**ADDENDUM TO THE
ARBORICULTURAL REPORT
RE-EVALUATION OF TREES
AT**

**THE TOTEM LAKE APARTMENTS SITE
At NE 115th Street & 124th Avenue NE
KIRKLAND, WA 98033**

April 7, 2011 Addendum

To: Jon Regala, Senior Planner
From: Deb Powers, Urban Forester
Date: July 12, 2011
Subject: Urban Forester Review / ZON11-00026

ATTACHMENT 1 - SITE PLAN

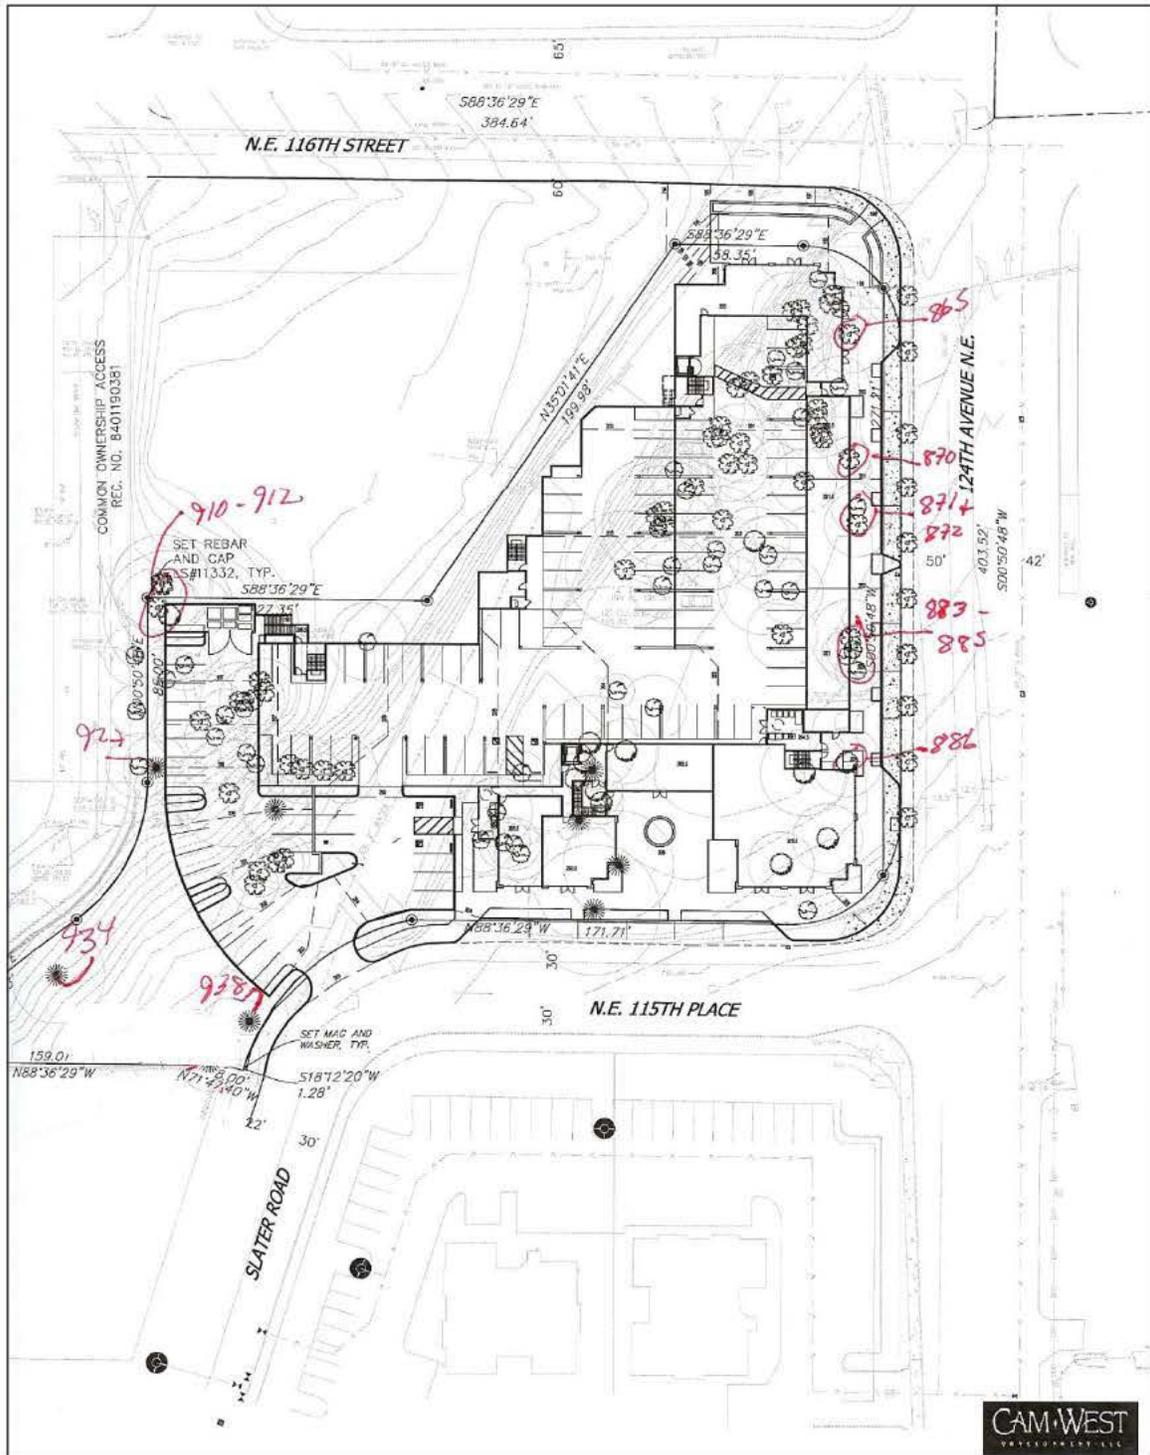
- CamWest is proposing to retain the 2 remaining conifers in the southwest property corner. They are # 934, and 938.
 - # 934 is a 39.8-inch Douglas Fir in Very Good condition. It should be able to be retained with all of the *Tree Protection Measures* in the February 10, 2011 report.

- # 938 is a 39.9-inch Douglas Fir right up along Slater Road. It is in Fair condition.
 - The base of the tree is very near the edge of the gravel shoulder. The construction of the parking lot will be within the dripline of the tree but only by a few feet.

- 5) Describe the impact of necessary tree removal to the remaining trees, including those in a grove or on adjacent properties;
- There are two landscape areas where CamWest is proposing to remove trees. They are the landscape zone along 124th Avenue NE between the back of the sidewalk and the side of the building; and the landscape area along the west property line between the west property line and the western edge of the parking lot.

- Trees Along 124th Avenue NE:
 - The trees in this area include # 865, 870, 883, 885, and 886.
 - # 865, 870, 883, and 885 are Big Leaf Maples and Bitter Cherry trees that are in Poor Condition. They are *Non-Viable*.

- *They should be removed for safety.*
 - # 866 is a 31.6-inch Black Cottonwood. It is in Good Condition but will not tolerate the loss of roots required for the construction- it would not be wind firm if retained. In addition, it is reaching an age where it will start dropping large limbs naturally.

- The tree should be removed for safety.
 - Trees Along the West Property Line
 - Trees include # 910, 911, 912, and 927. All four are in Fair Condition.

- However, the topography of the area will require the installation of some sort of retaining wall. These four trees will not survive long-term from the impacts of the construction of the retaining wall and parking lot.

- If the Tree Protection Measures are followed the tree should tolerate the incursion fine and suffer no long-term problems.
 - Specific tree protection measures that must be followed include:

1. Tree protection fencing place prior to any construction work commencing.
 2. Cover the area within the tree protection fence with 10 to 12 inches of wood chips.

3. Follow the section 5 excavation techniques listed above and on Page 27 of 30 of the February 10, 2011 report and repeated above.
- 4) For trees not viable for retention, a description of the reason(s) for removal based on poor health, high risk of failure due to structure, defects, unavoidable isolation (wind firmness), or unsuitability of species, etc., and for which no reasonable alternative action is possible must be given (pruning, cabling, etc.);
